## Sales and Service

### Change in Appearance of Input/Output Signal Connectors of General-Purpose AC Servo Amplifiers

MR-J4W2-B, MR-J4W3-B

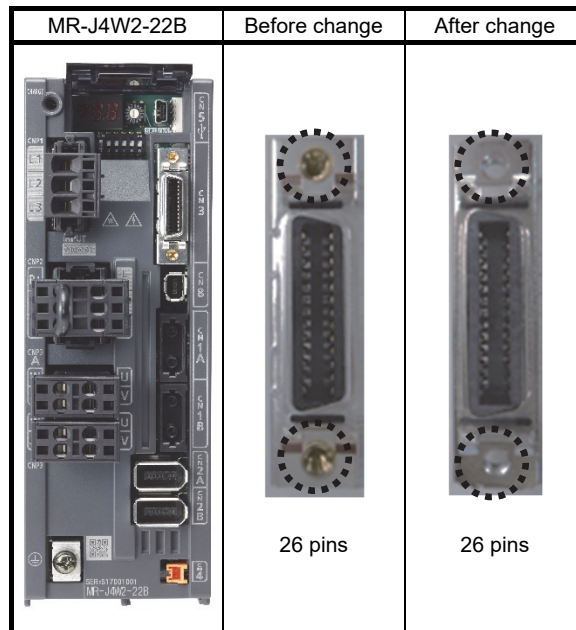
The input/output signal connectors (CN3) will have tapped holes instead of lock nuts. The existing connector sets and cables will fit into the changed connectors properly.
